Released under the Creative Commons Attribution Share-Alike 3.0 License http://creativecommons.org/licenses/by-sa/3.0				⊗	⊗	○	○
TITLE: \${PROJECTNAME}							
Design by: J. Bartlett						REV: v12	
Revision By: E. Orosel							
Date: \${CURRENT_DATE}						Sheet: \${#}/\${##}	
Title:							
Size: User				Date:		Rev:	
KiCad E.D.A. kicad-cli 7.0.6-7.0.6-ubuntu22.04.1						Id: 1/1

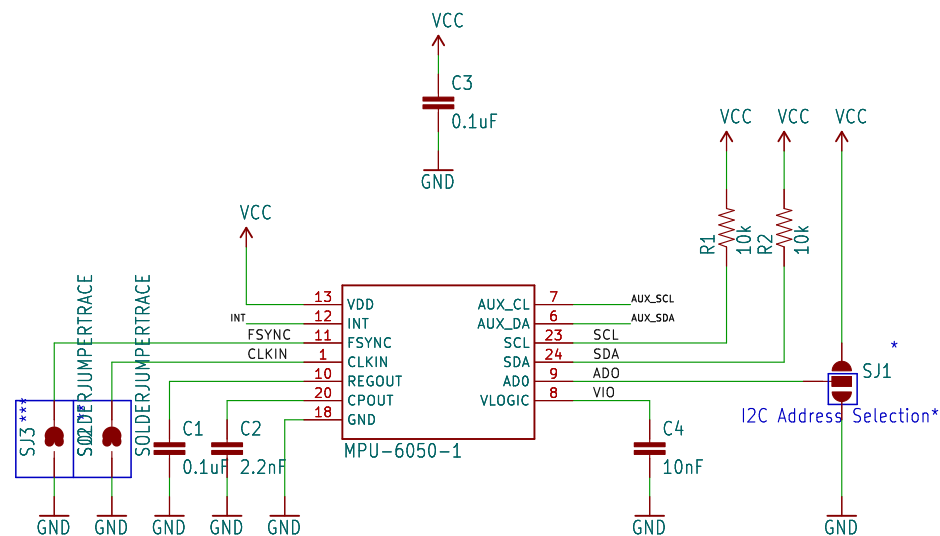
Changes to V11
SCL and SDA were switched on V10, fixed on V11
Broke out VLOGIC line
C2 was mislabeled as 10nF, should have been 2.2nF.
Added selectable jumpers to CLK, FSYNC and ADO
Minor layout changes
Played around with IC footprint.
Added 4 small tcream squares to middle pad.
Rounded and elongated pads.

BOM changes
YES
C2 is now 2.2nF instead of 10nF

Changes to V12:
-0402 --> 0603
-Changed Z-Axis symbol to reflect proper
orientation from circle with x to circle with dot
-Changed NET labels in schematic to flags
